Well Name: OUTRIDER 27 FED	Well Location: T24S / R32E / SEC 27 / SWSW / 32.18225 / -103.666909	County or Parish/State: LEA / NM
Well Number: 103H	Type of Well: OIL WELL	Allottee or Tribe Name:
Lease Number: NMNM016353	Unit or CA Name:	Unit or CA Number:
US Well Number: 3002550234	Operator: XTO ENERGY INCORPORATED

Sundry ID: 2745075

Type of Action: APD Change

Procedure Description: **Surface hole Change, First and Last Take Point Changes, Bottomhole Location Change, Pool Chg, Drilling Plan Change, Casing/Cement Change XTO Energy Inc. requests permission to make the following changes to the original APD: No Additional Surface Disturbance Pool Change: Fr/Mesa Verde; Wolfcamp (98252) to WC-25 G-06 S253206; Bone Spring (97899) SHL: fr/353'FSL & 1284'FWL to 353'FSL & 1284'FWL, NMNM016353 FTP: fr/50'FSL & 1650'FWL to 100'FSL & 330'FWL, NMNM016353 LTP: fr/50'FNL & 1650'FWL to 1220'FSL & 330'FWL, NMLC029694 BHL: fr/50'FNL & 1650'FWL to 1270'FSL & 330'FWL, Section 15-T24S-R32E NMLC029694 Casing/Cement design per the attached drilling program. Attachments: C102 Drilling Program Directional Plan

WELL LOCATION AND ACREAGE DEDICATION PLAT

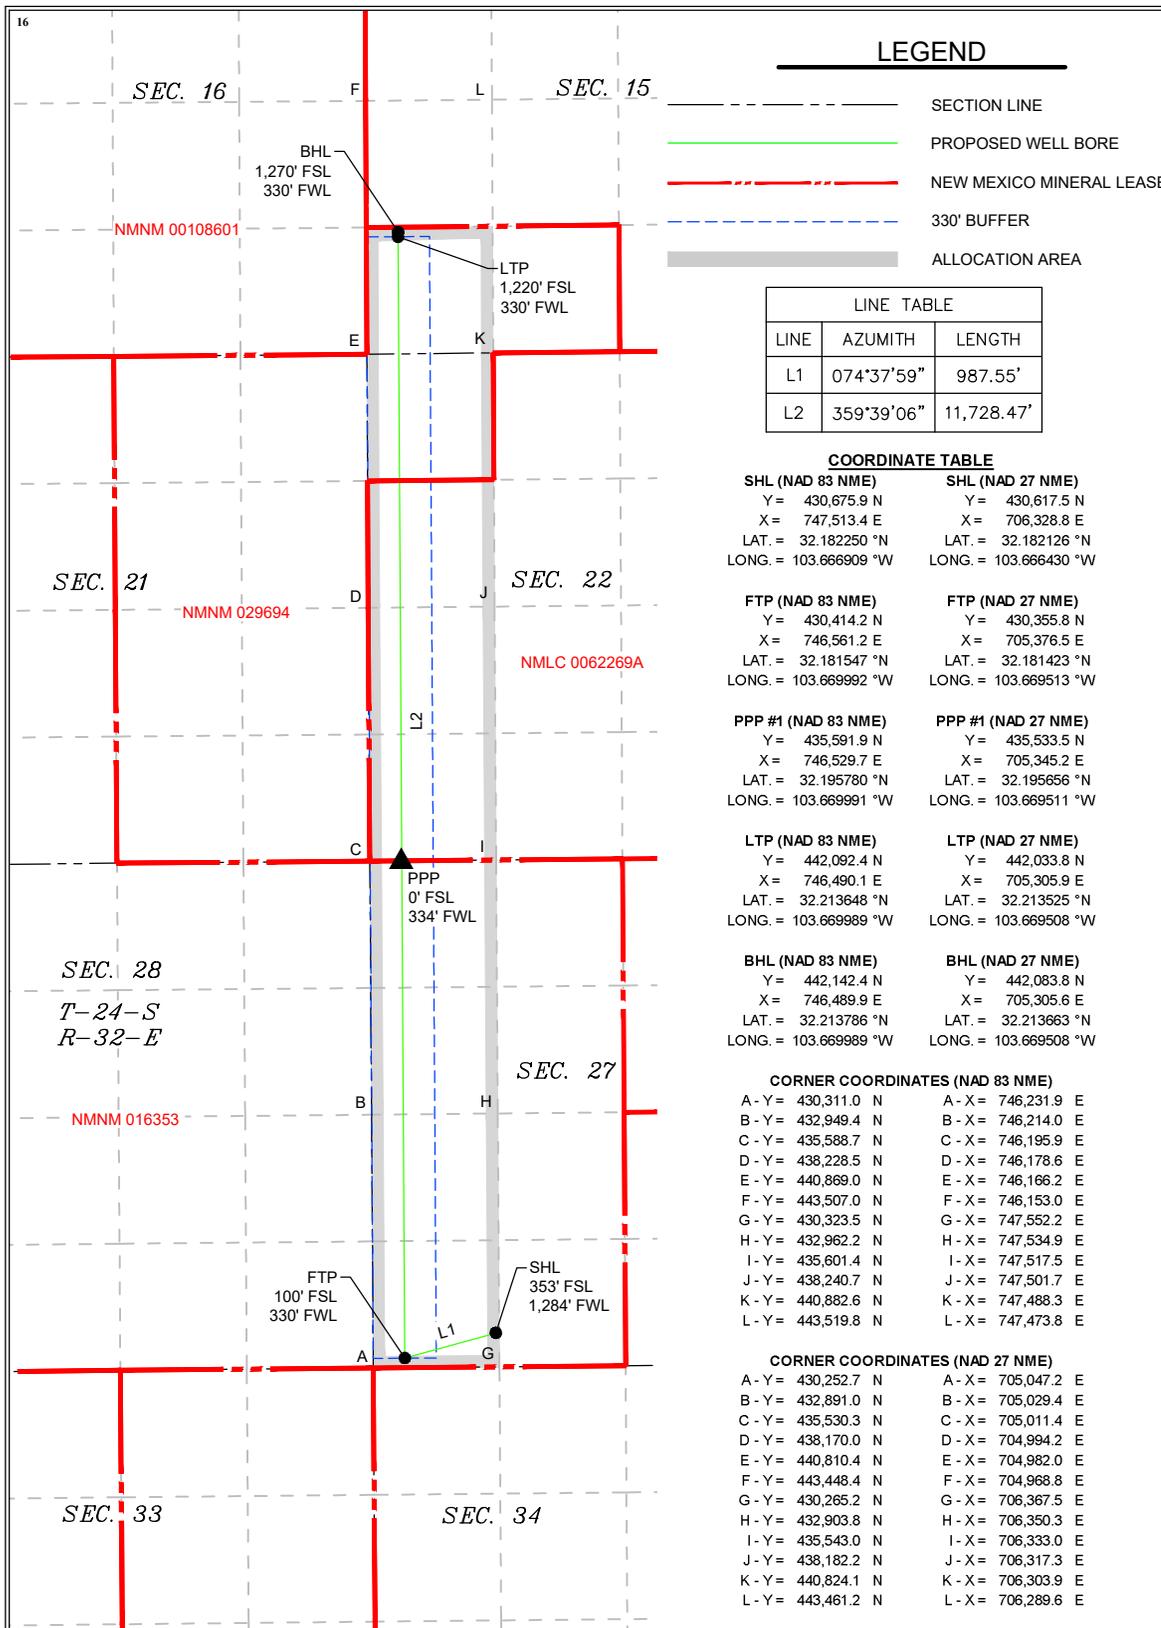
LTP: fr/50FNL & 1650FWL to 1220FSL & 330FWL, NMLC029694

BHL: fr/50FNL & 1650FWL to 1270FSL & 330FWL, Section 15-T24S-R32E NMLC029694
